License and Variance Board Meeting - Final

-
- H. **V24-073** Public Hearing - Variance Request - V24-073 - Allow encroachment into the City's 50 ft. undisturbed stream buffer - Land Lot 488 - 0.25 acres - 1088 Parkview Place - Adam Ingleson

RE: VARIANCE CASE V24-073
1088 Parkview Place – Allow encroachment into the City’s 50-foot undisturbed stream buffer

VARIANCE CASE V24-074
1088 Parkview Place – Allow encroachment into the City’s 75-foot impervious surface setback

Figure – 2
Site Plan

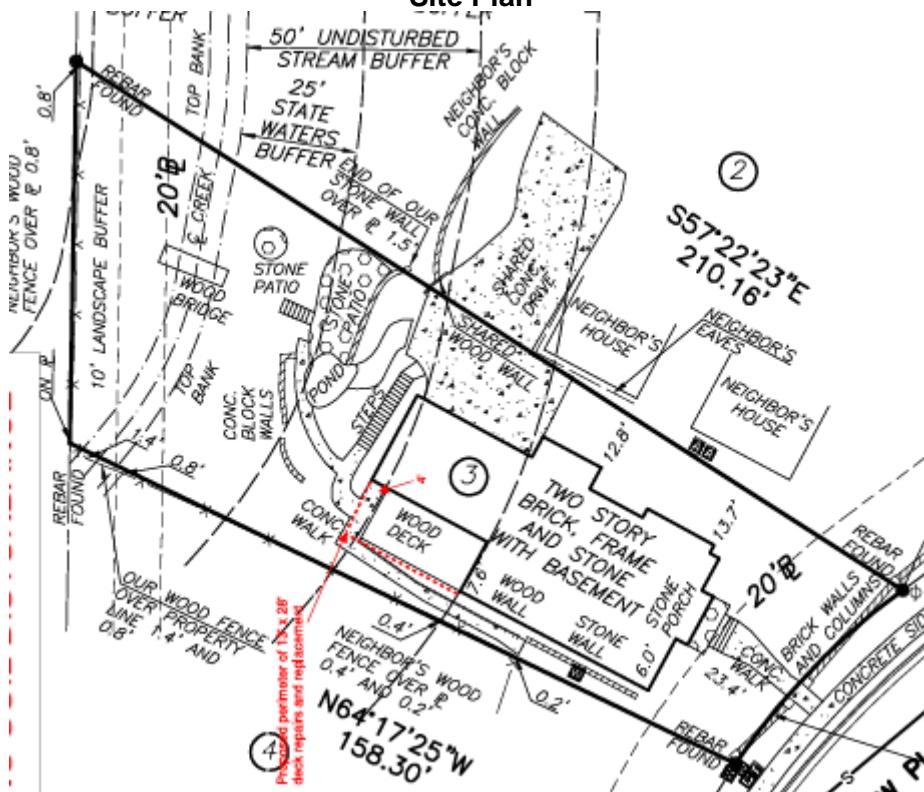
The applicant is proposing to replace an existing roughly 294 square foot deck with a roughly 364 square foot deck which will be half open-air deck and half a screened-in porch. The rear yard and a majority of the home itself is greatly encumbered by the State’s 25-foot undisturbed buffer, the City’s 50-foot undisturbed stream buffer, and the City’s 75-foot impervious surface setback, with no section of the rear yard untouched by stream buffers. Since the property was platted in 2004, prior to the Stream Buffer Protection Ordinance in 2005, the hardship is not self-created. No other variances are needed as the property is below their impervious coverage maximum of 45%.

Since the stream buffer encroachment occurred in 2004 and the additional land disturbing activity is considered minor and over previous impervious material, the City Engineer has determined that no remediation is required in order to support the variances.

Due to the existing stream buffers encumbering the entirety of the rear yard and the existing home, Community Development believes these are the minimum variances needed to allow for any replacement of the existing deck and that there should be no negative impacts to adjacent properties if approved. At the time of this report, Community Development has not received any calls in opposition to the request.

1. Approval of the requested variances shall be conditioned upon substantial compliance with the site plan and elevations submitted with the variance application.
